ADDENDUM NO. 02

PROJECT: **VIGO COUNTY SECURTY CENTER**
Terre Haute, Indiana 47807

ARCHITECT: **DLZ INDIANA, LLC**
157 East Maryland Street
Indianapolis, Indiana 46204
317.633.4120
DLZ Project Number: 1663-1190-90

DATE: **September 19, 2019**

9 TYPICAL SKYLIGHT SUPPORT AREA B
S-554 SCALE: 3/4" = 1'-0"

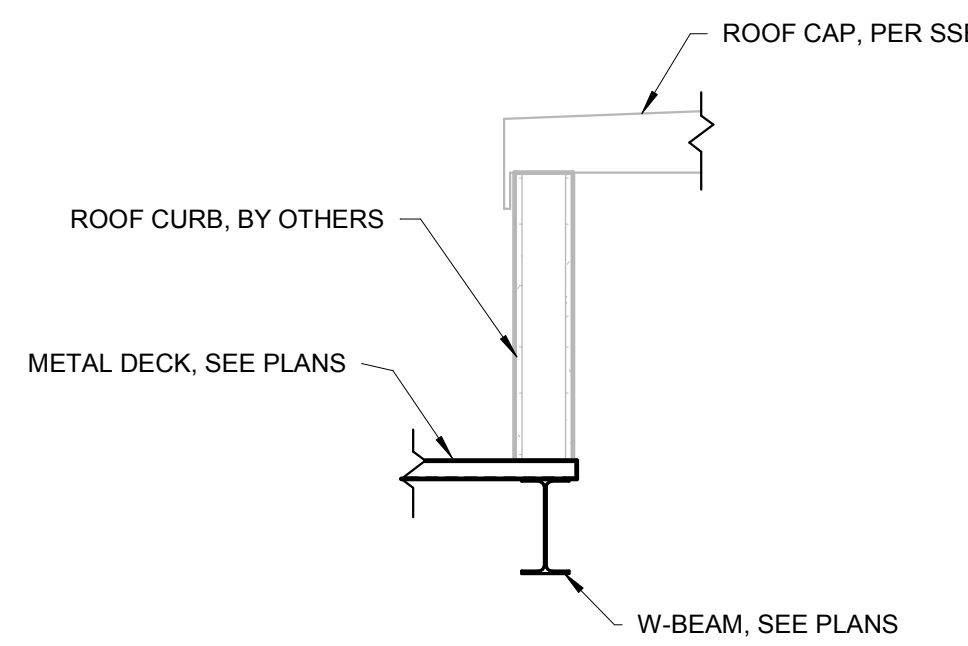
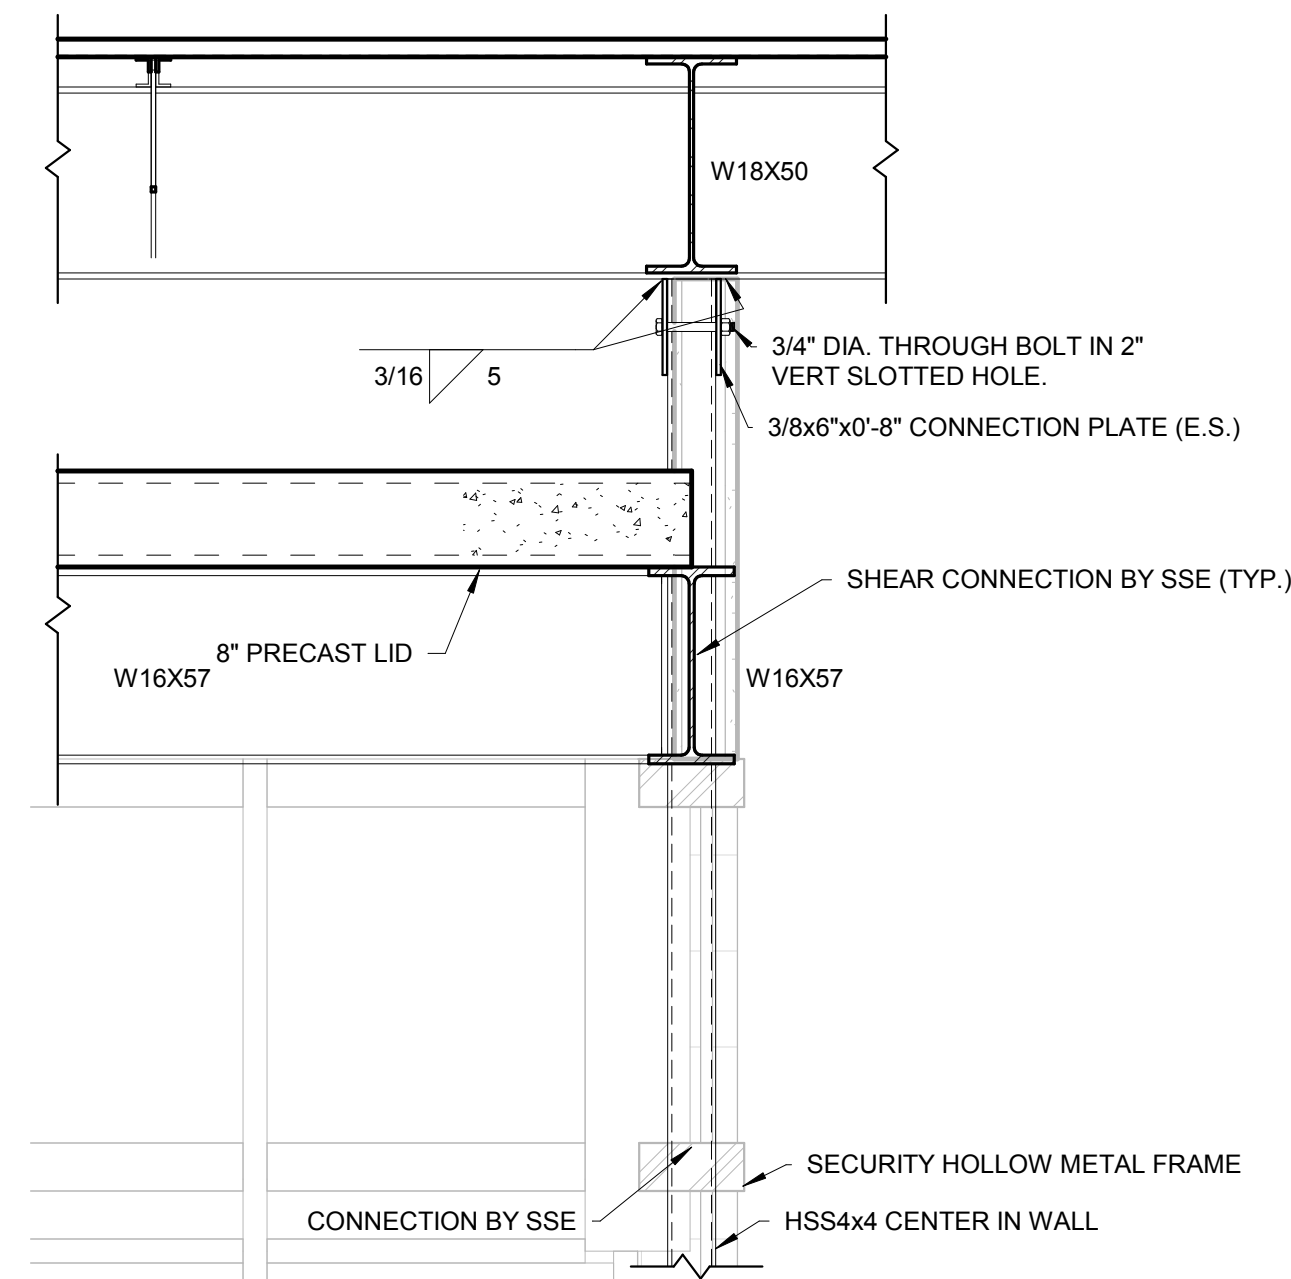
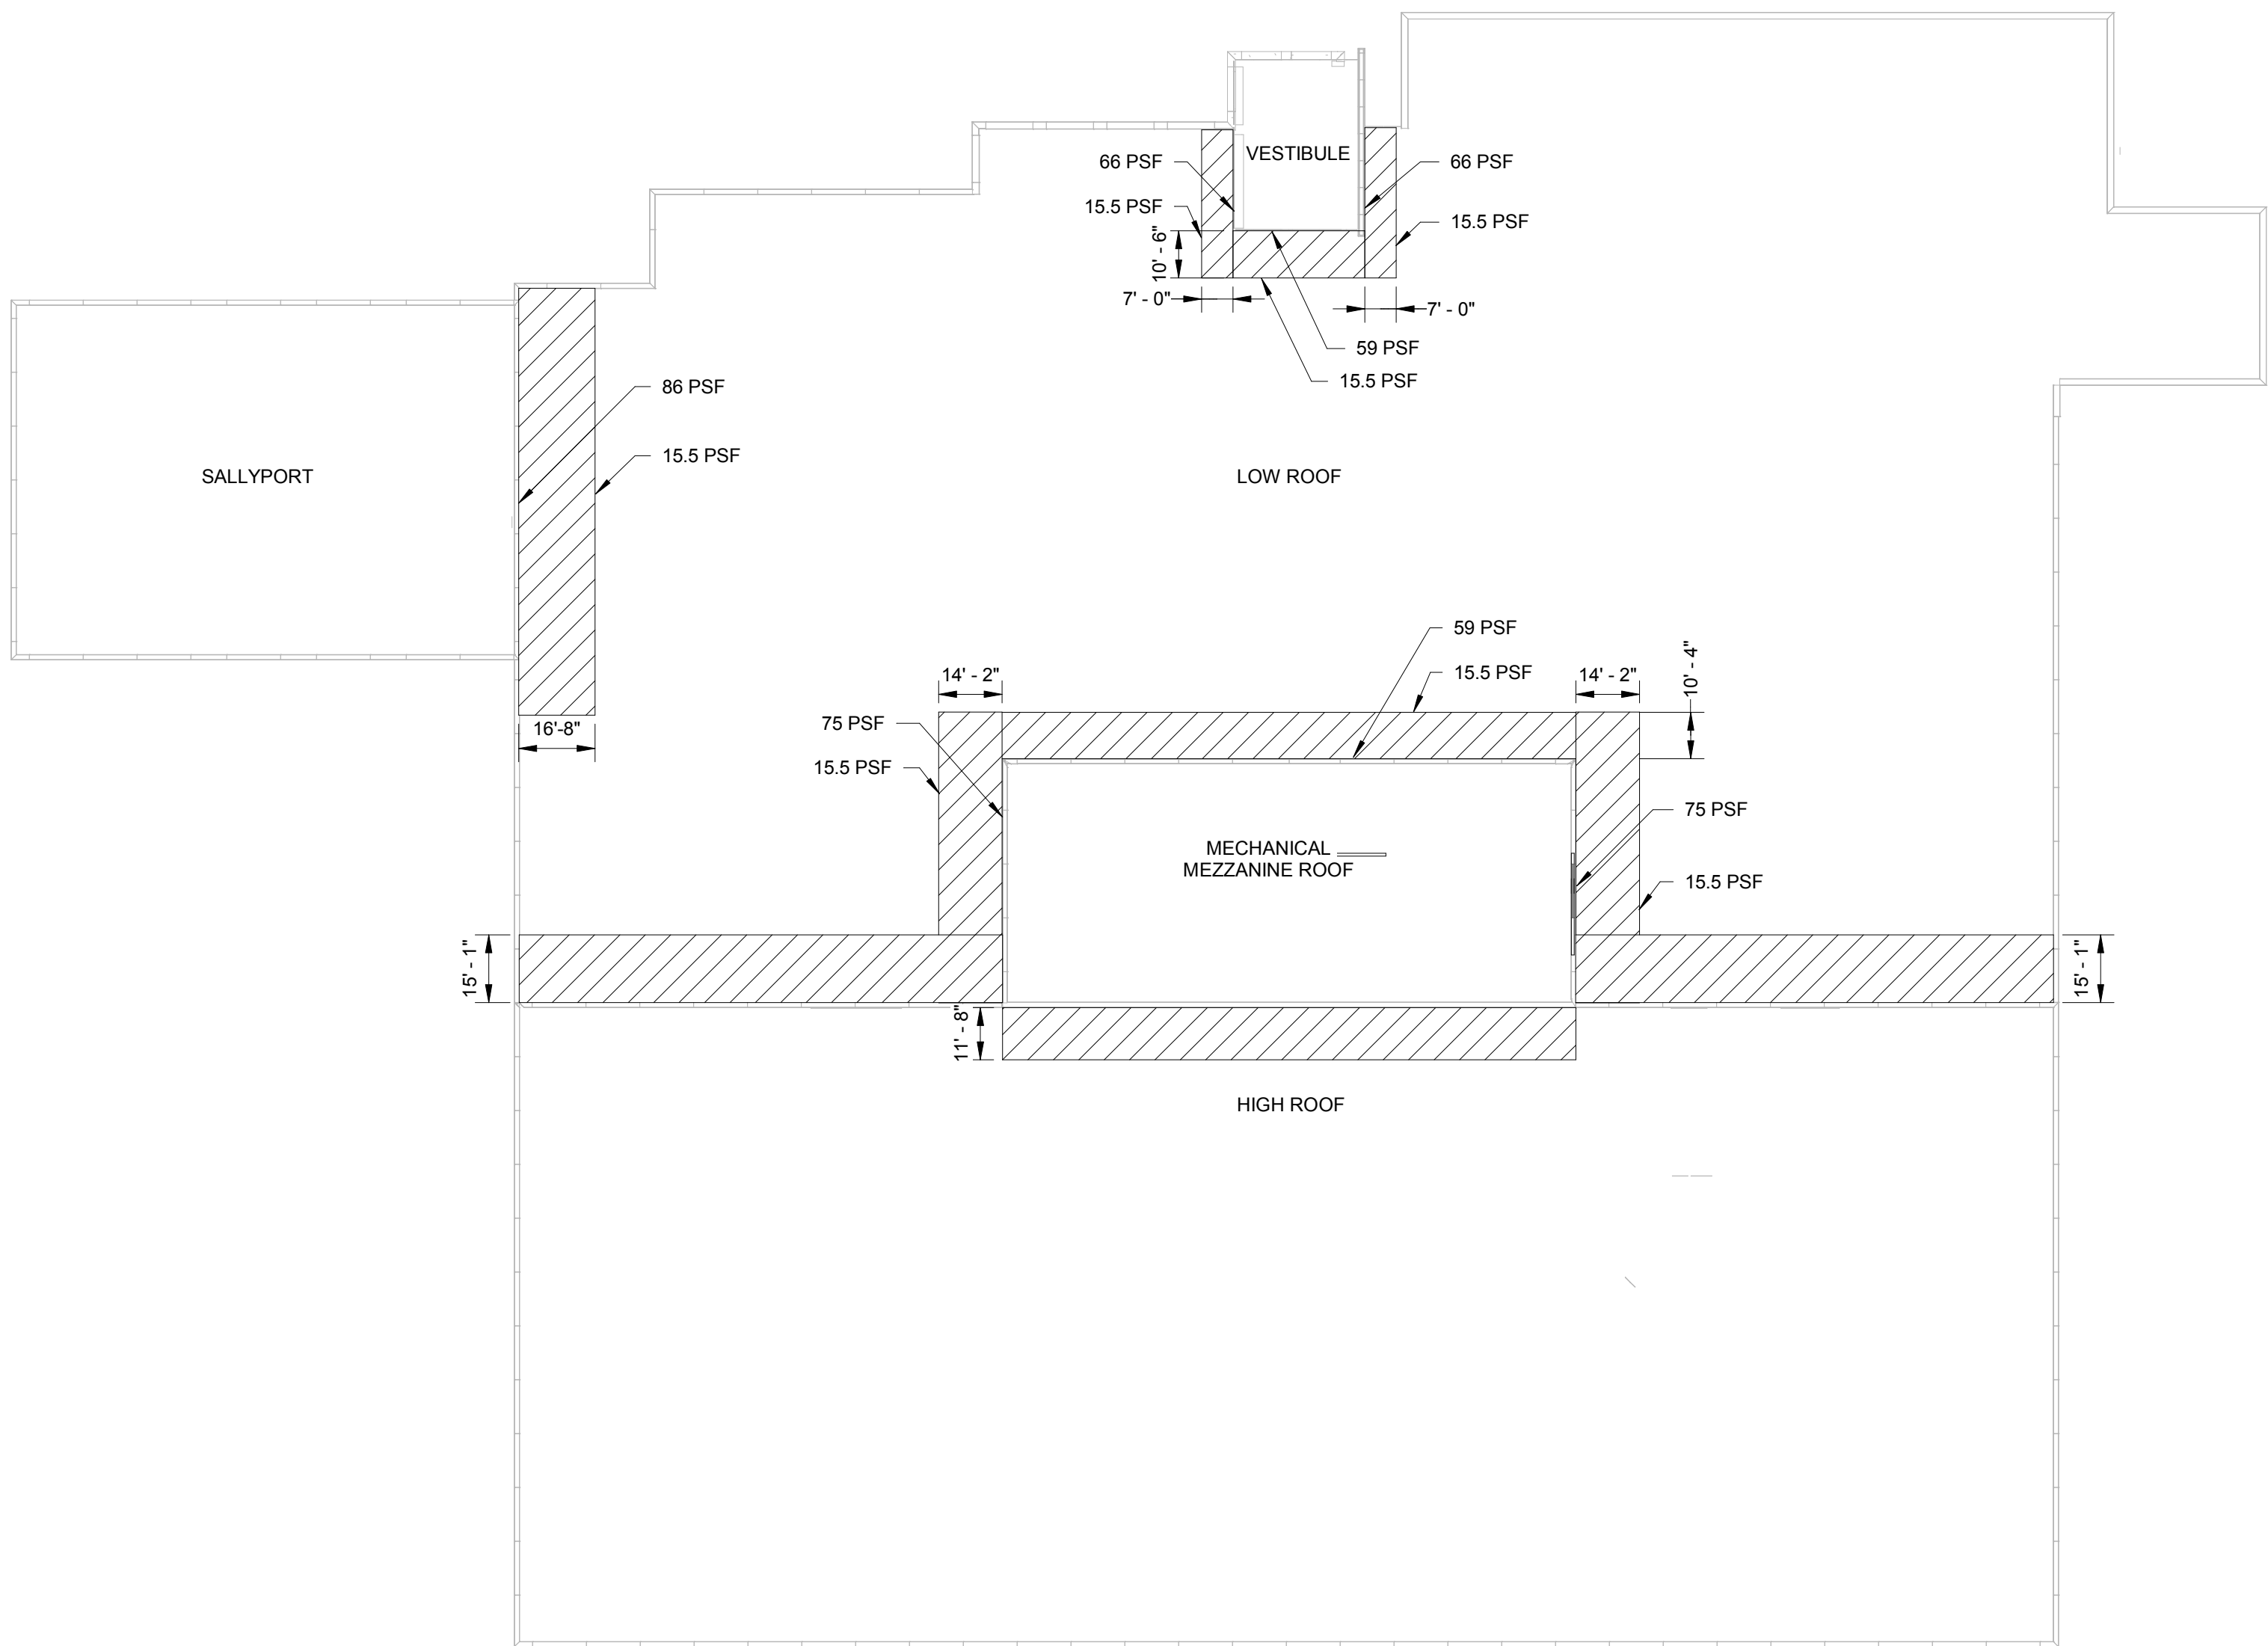
- a. Remove sheet S-103-B and replace with S-103-B dated 9/19/19. HSS beams added to corridor skylights for support of security screen.

5 FLAT SKYLIGHT CURB DETAIL
SCALE: 1 1/2" = 1'-0"

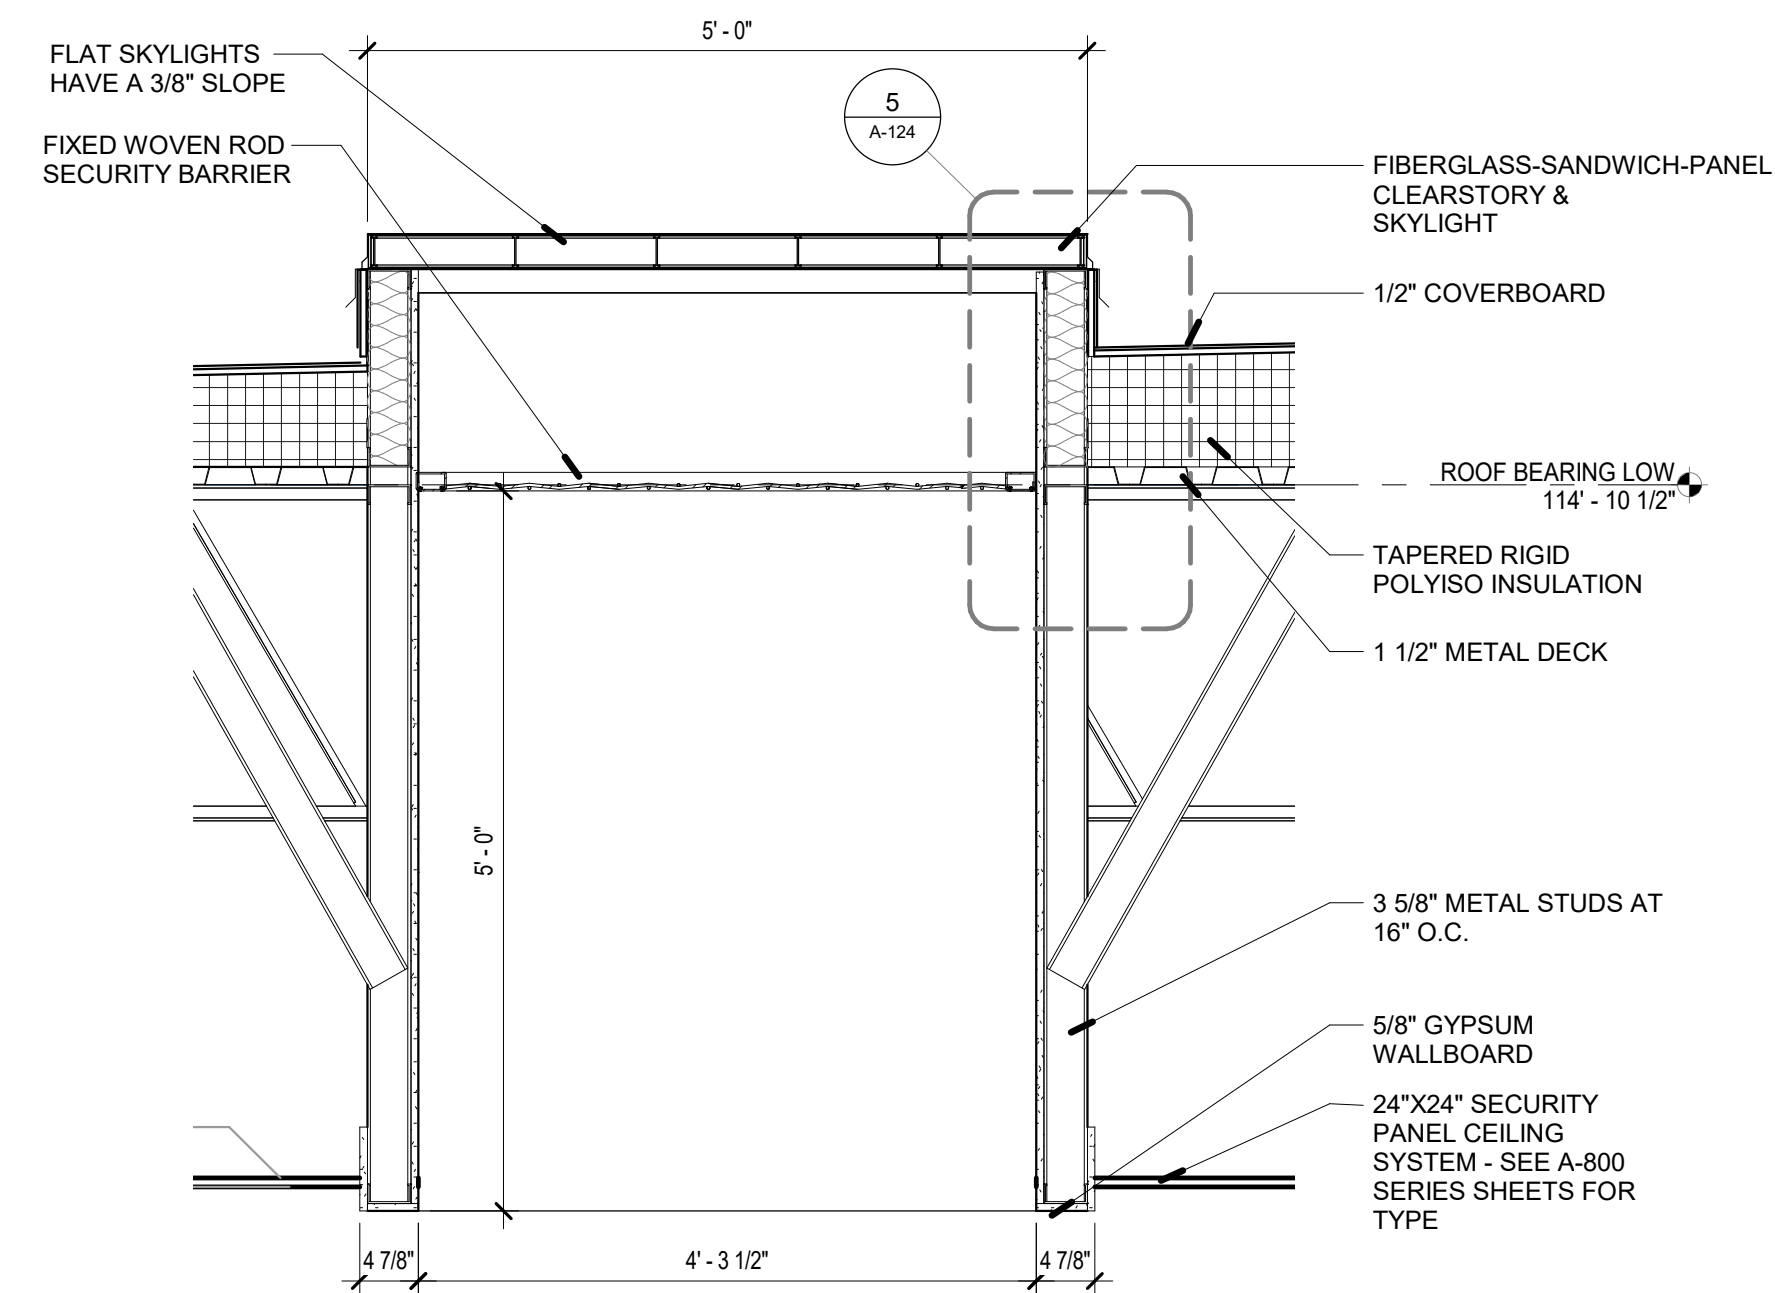
- a. Skylight Detail 3
 - 1. Revise steel framing at security barrier and metal deck.
- Flat Skylight Curb Detail 5.
- 2. Revised steel framing at security barrier and metal deck.

DOOR FRAME ELEVATIONS - 1' - 0" = 1/4"

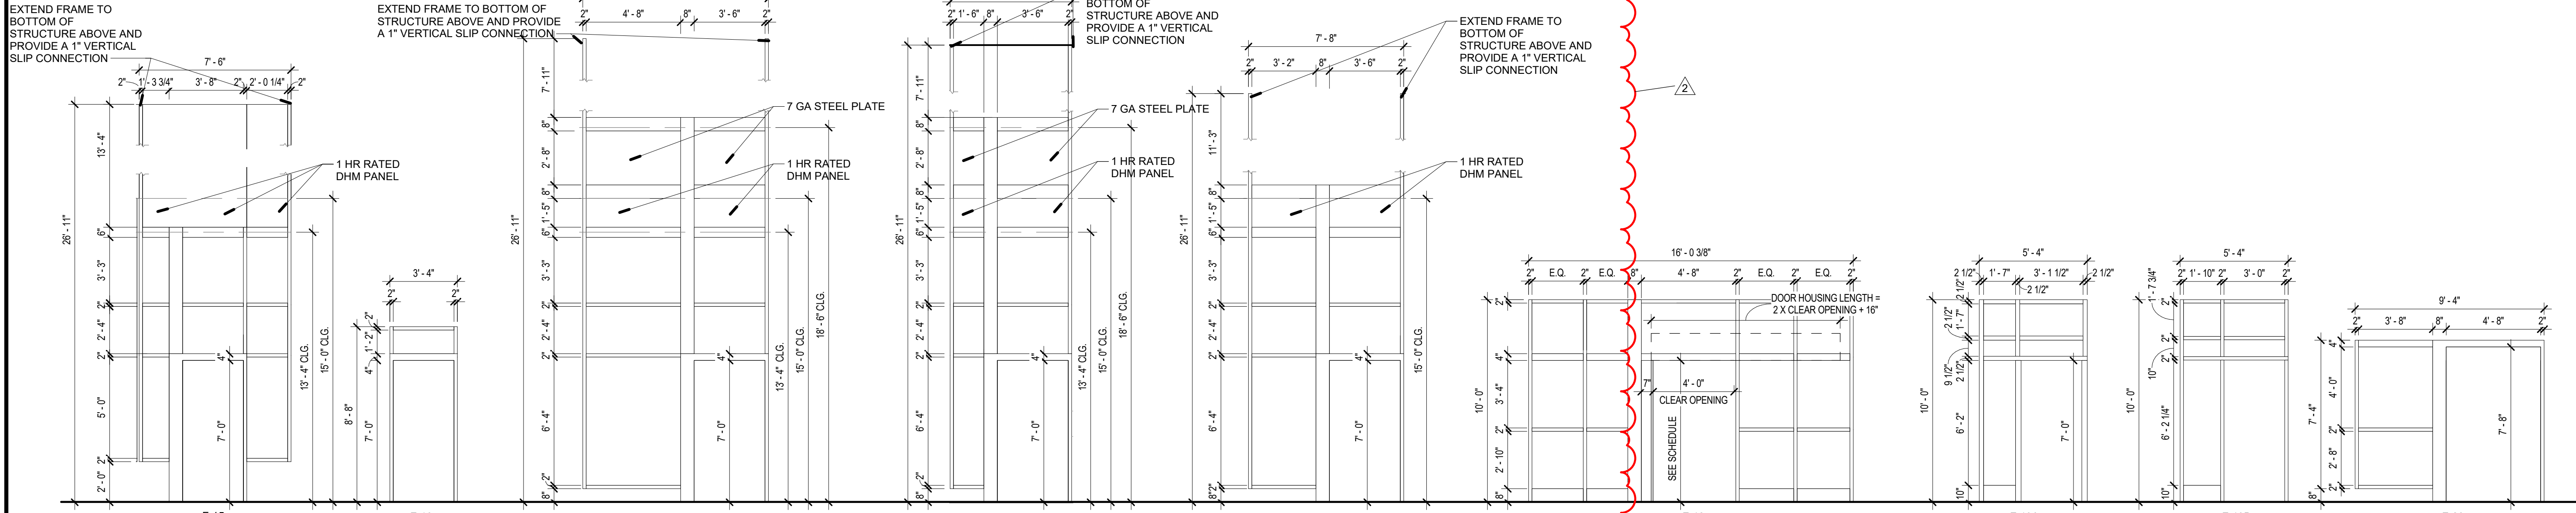
- a. Frame Elevation F-15. Additional dimensions added to clarify frame member size and locations.
 - 1. Extend end frames vertically to bottom of structure above and provide 1” vertical slip connection.

- 2. Added note for “1 HR RATED DHM PANEL.”
- b. Frame Elevations F-17 and F-17A. Additional dimensions added to clarify frame member size and locations.

- 1. Extend end frames vertically to bottom of structure above and provide 1” vertical slip connection.
 - 2. Revise the note “METAL PANEL” to read “7 GA STEEL PLATE”.

- 3. Revise the note “1 HR RATED METAL PANEL SYSTEM” to read “1-HR FIRE-RATED DHM PANEL”.
 - 4. Note location of 18’-6” ceiling line.
- c. Frame Elevation F-17B. Additional dimensions added to clarify frame member size and locations.

- 1. Extend end frames vertically to bottom of structure above and provide 1” vertical slip connection.
 - 2. Added note for “1 HR RATED DHM PANEL.”
